ITEM FOR ENVIRONMENTAL COMMISSION AGENDA

NAME & NUMBER OF PROJECT: 8020 Parmer Lane SH 130 NW
C8J-2021-0141.0A

REQUEST: Variance request is as follows:
1. Request to vary from LDC 30-5-341 to allow fill over 4 feet to 15 feet.
2. Request to vary from 30-5-261(G) to allow floodplain modification in a critical water quality zone buffer.

STAFF RECOMMENDATION: Staff recommends this variance, having determined the findings of fact to have been met.

EXHIBIT 1 – CUT/FILL EXHIBITS

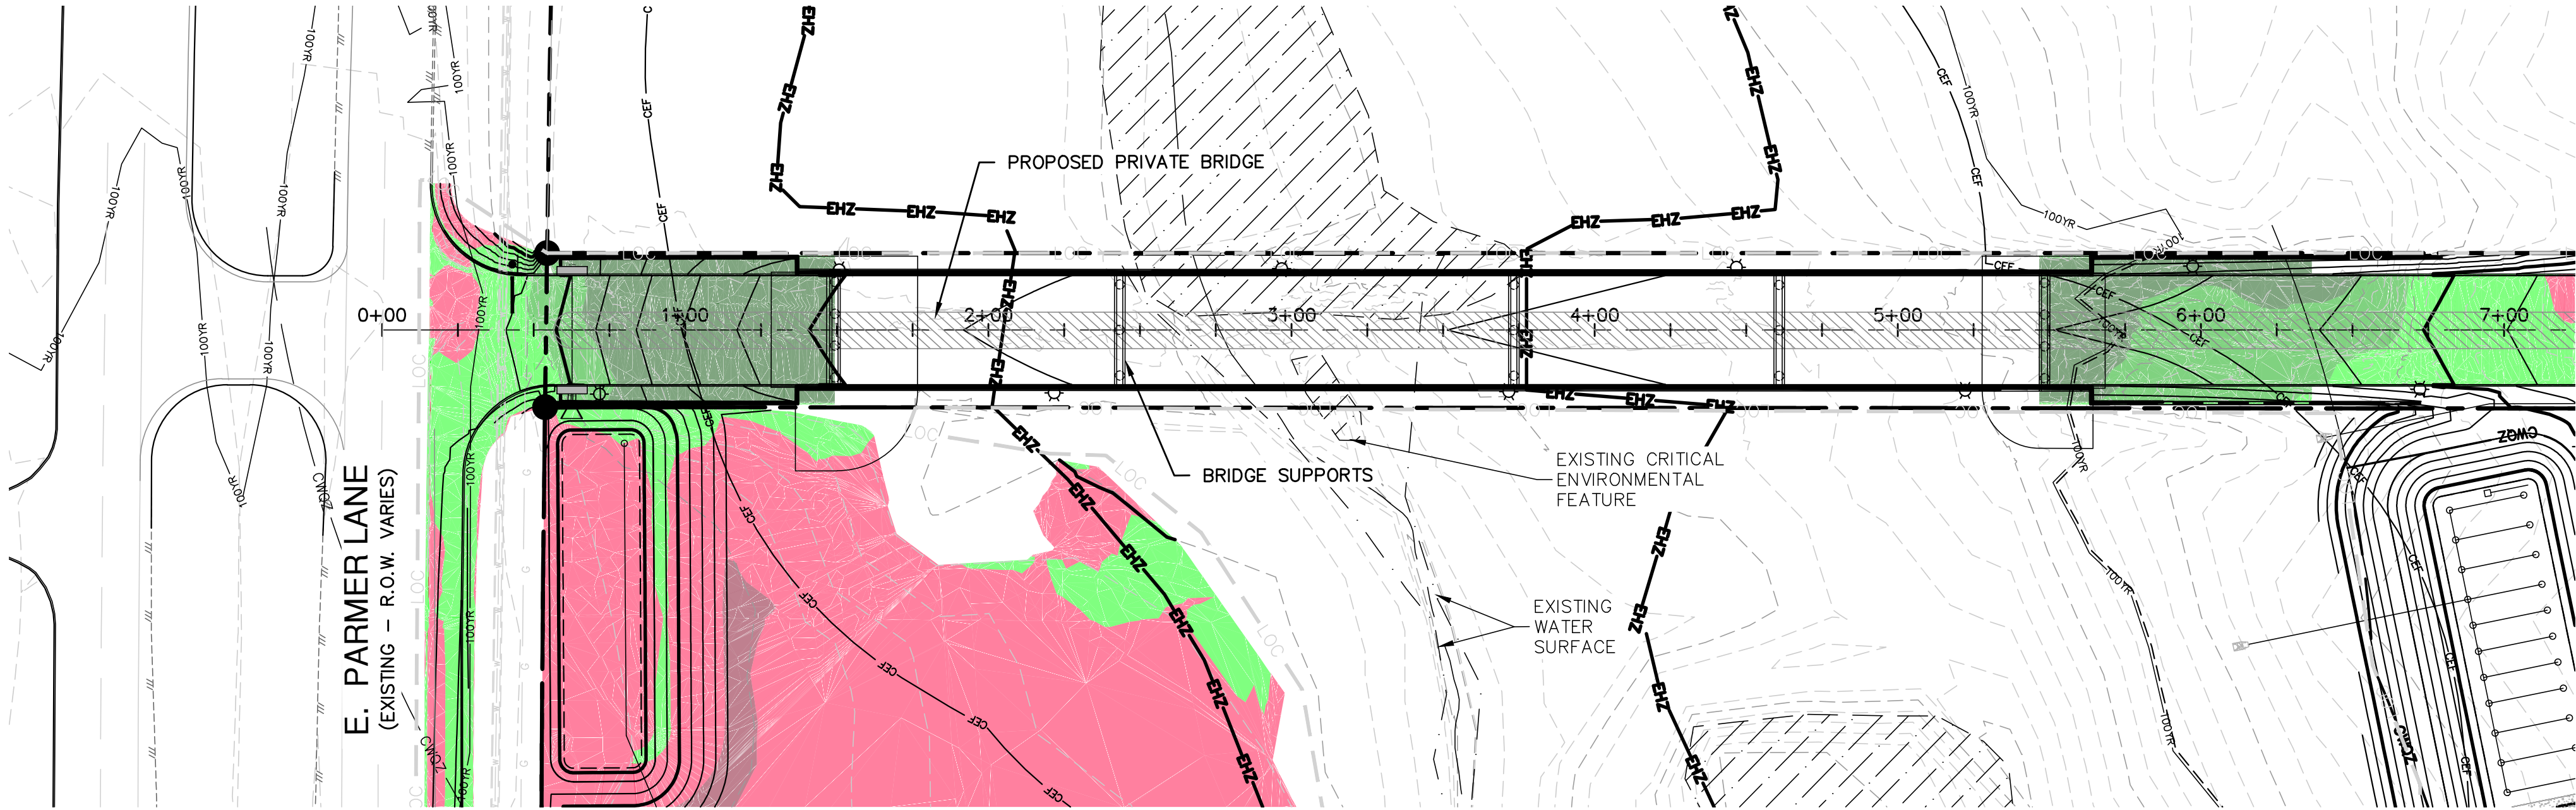
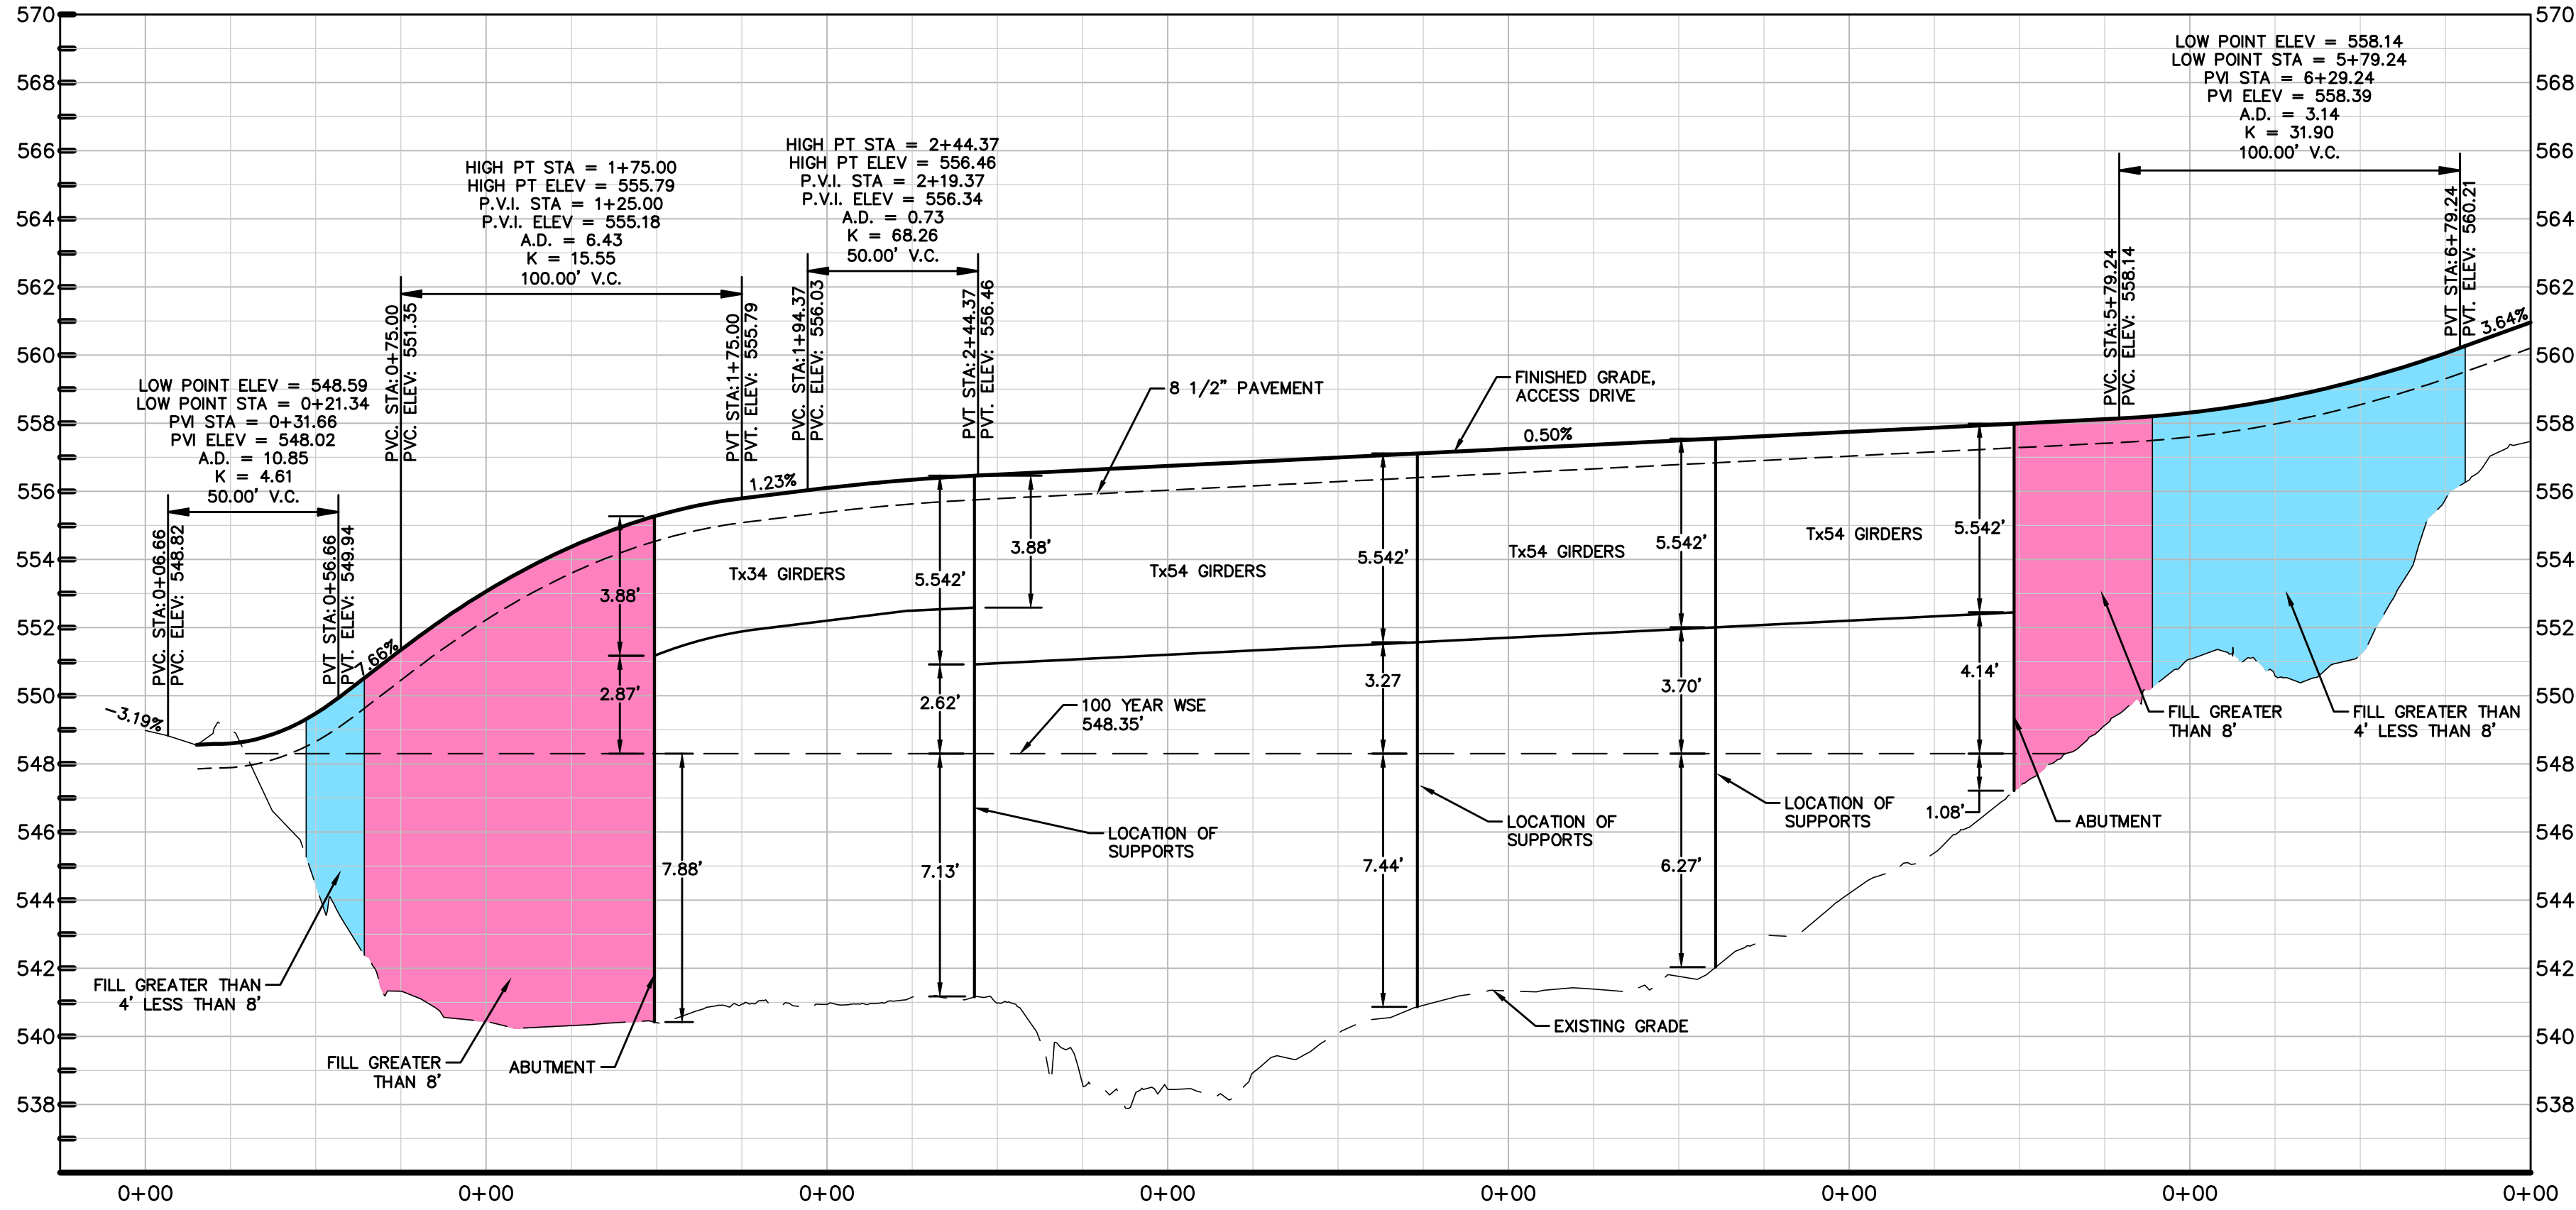
The fill variance is required in order for the applicant to access the site with a bridge spanning wetlands, floodplain, and creek buffer.

Yes The variance for fill is the minimum necessary to build the bridge to a height that will allow safe access to the site across the floodplain.

Yes The proposed fill is the minimum necessary to build the bridge to access the property.

EXHIBIT 3 – WETLAND MITIGATION

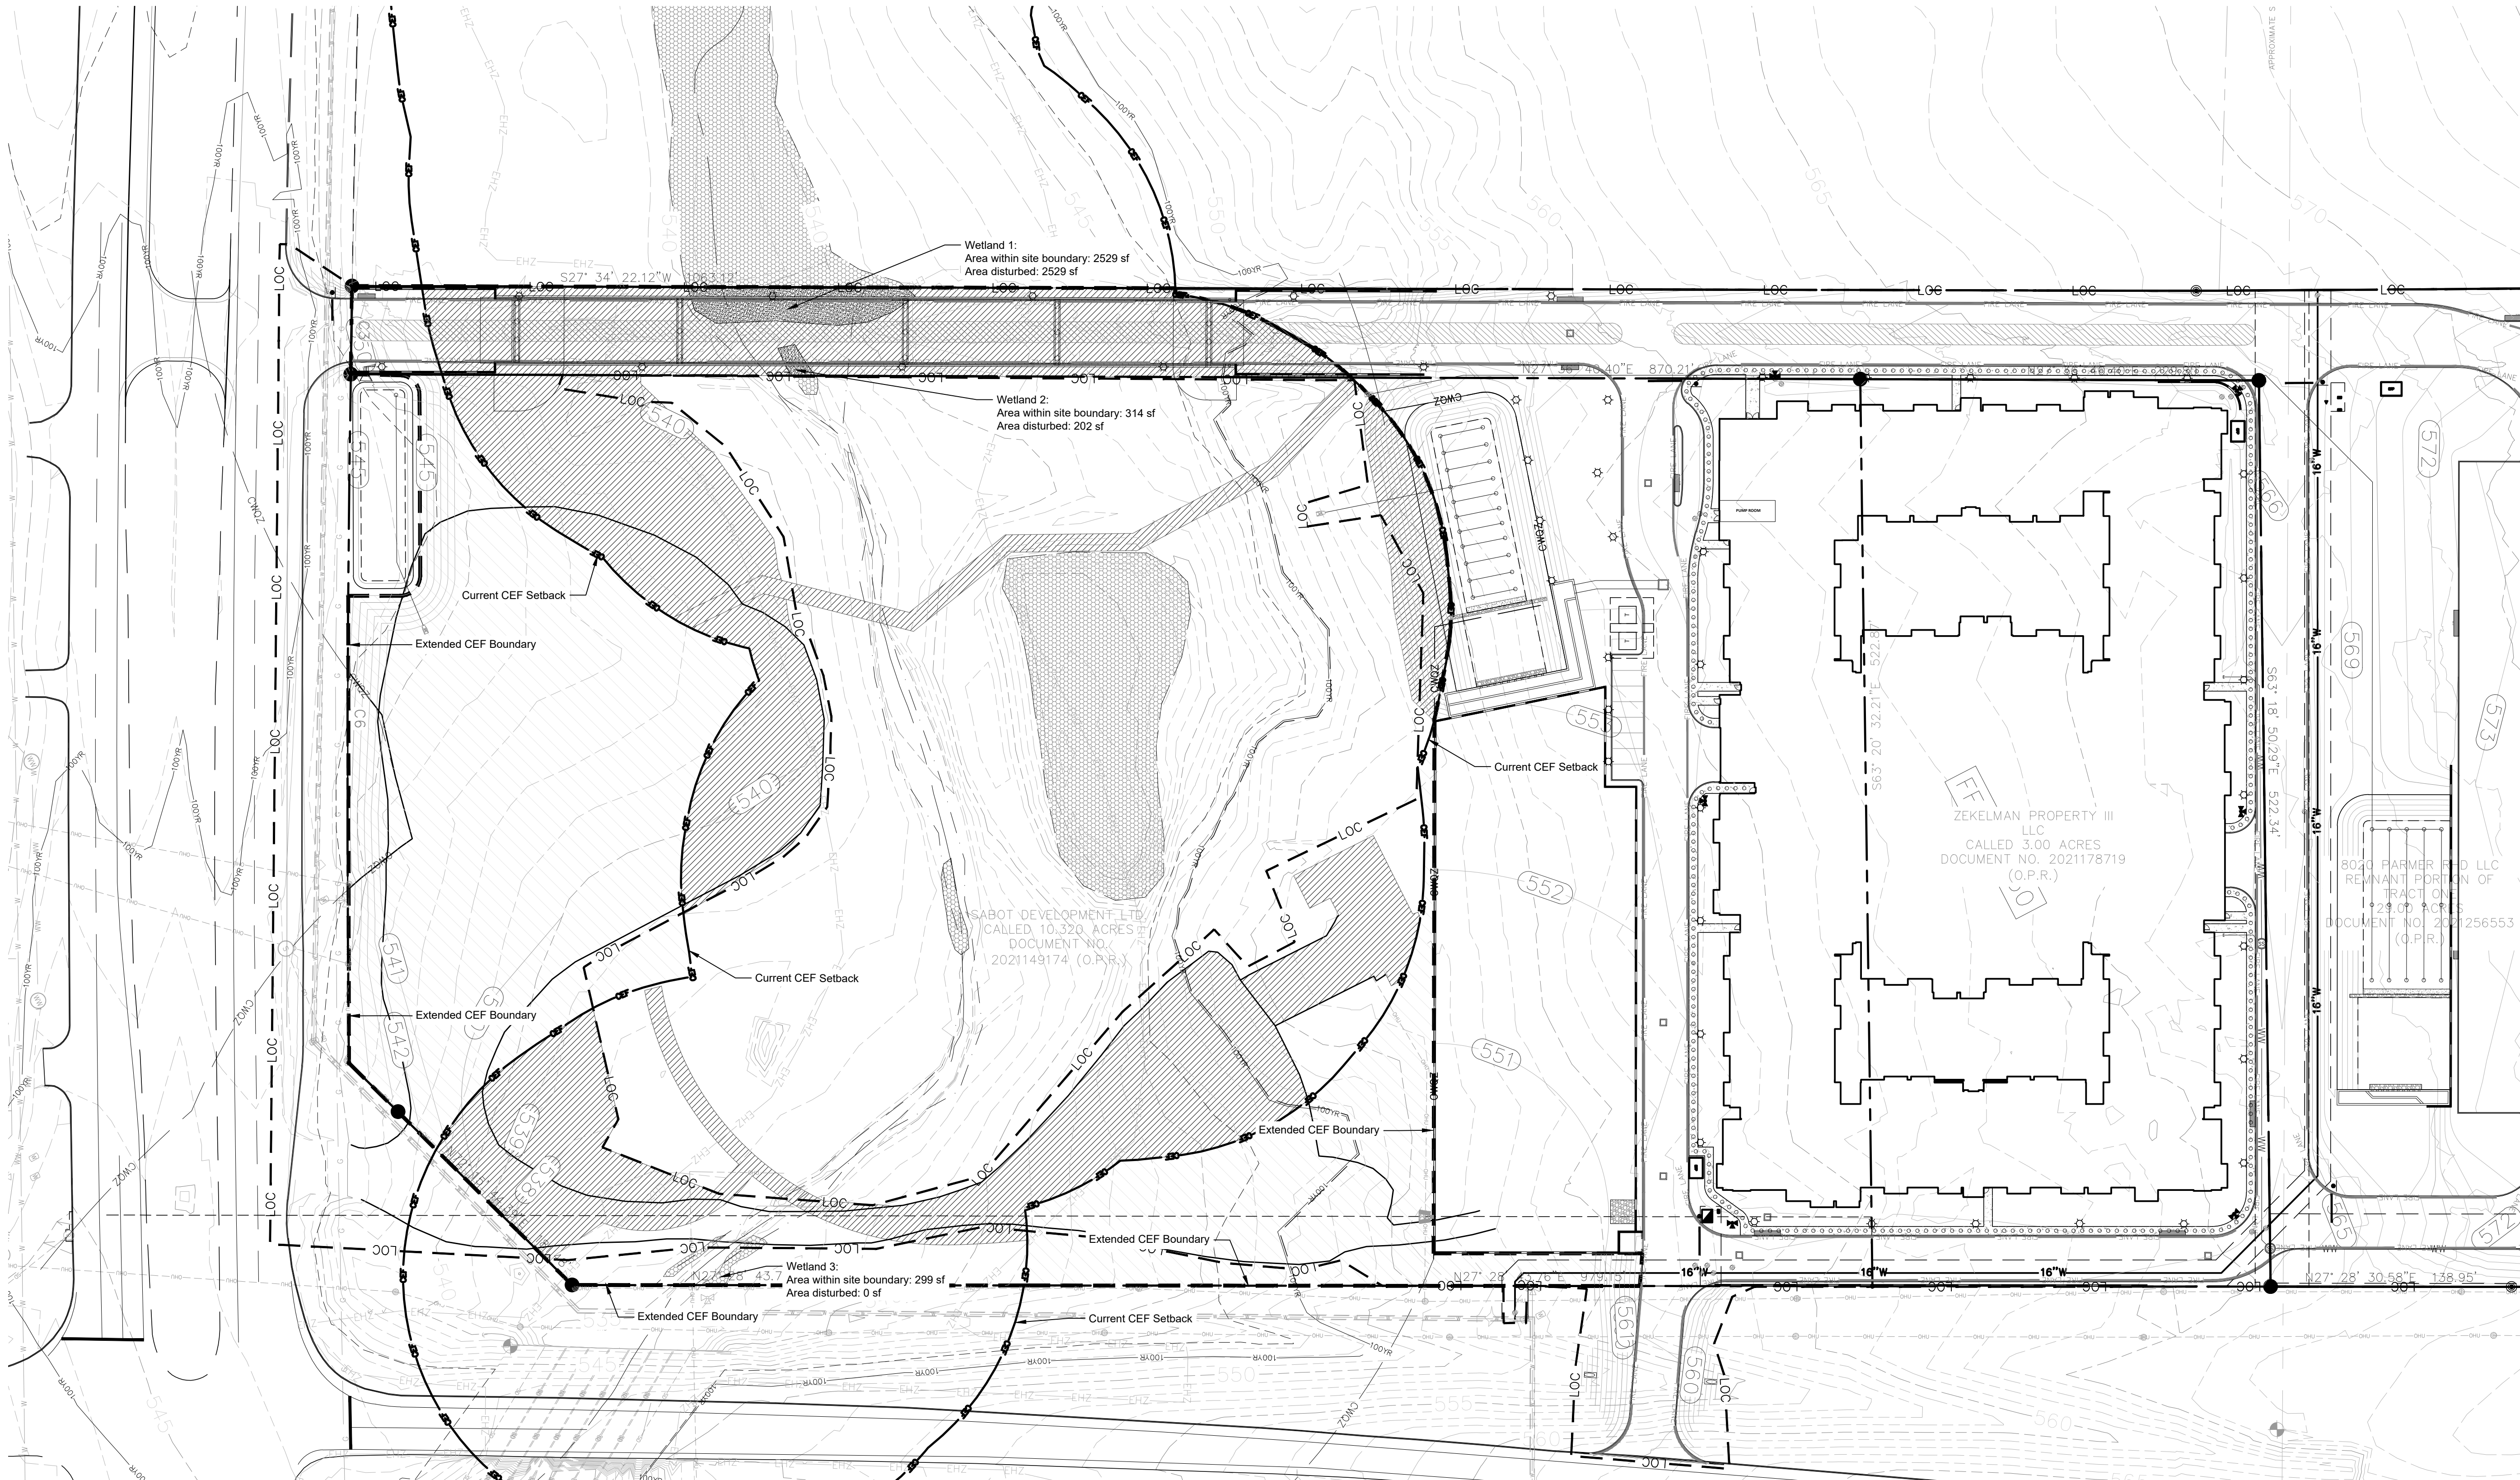
Yes A flood study has been completed and reviewed by the City of Austin to prove no adverse impact to other properties. The bridge piers have been placed to minimize the impact to the waterway and existing wetland CEFs. Existing impervious cover in the CEF and CWQZ will be removed, and a CEF mitigation and floodplain mitigation plan has been proposed and reviewed by City of Austin staff.

Yes The variance does not create a probability of harmful environmental consequences. A flood study has been completed and reviewed by the City of Austin to prove no adverse flooding impact to other properties. The bridge piers have been placed to minimize the impact to the existing wetlands, and a wetland mitigation and floodplain mitigation plan has approved by City staff.
